WIRES TO GOVERNOR SWITCH REVERSED

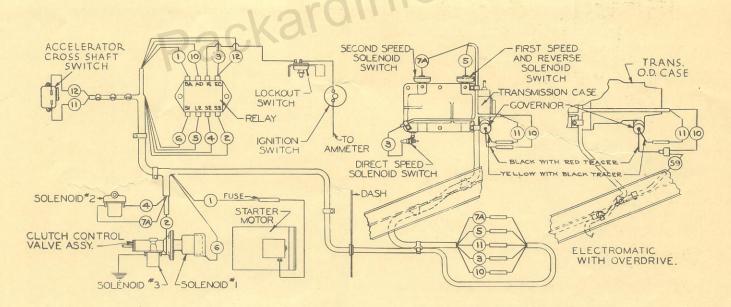
When the black (No. 10) and green (No. 11) wires are reversed, it will allow enough current to pass through the Electromatic relay to discharge the battery when the car is placed in storage or is not operated for several days.

This condition can be quickly checked by disconnecting the wire from the AD terminal of the Electromatic relay and striking it against the terminal with the ignition switch off. If a spark occurs, it indicates the wires are reversed.

The green wire (No. 11) should be connected to the yellow with black tracer wire. The black wire (No. 10) should be connected to the black with red tracer wire. On Aero-Drive cars, the black with red tracer wire (No. 59) from the kickdown switch to the governor is also connected to black with red tracer wire from the governor through a three-way connector.
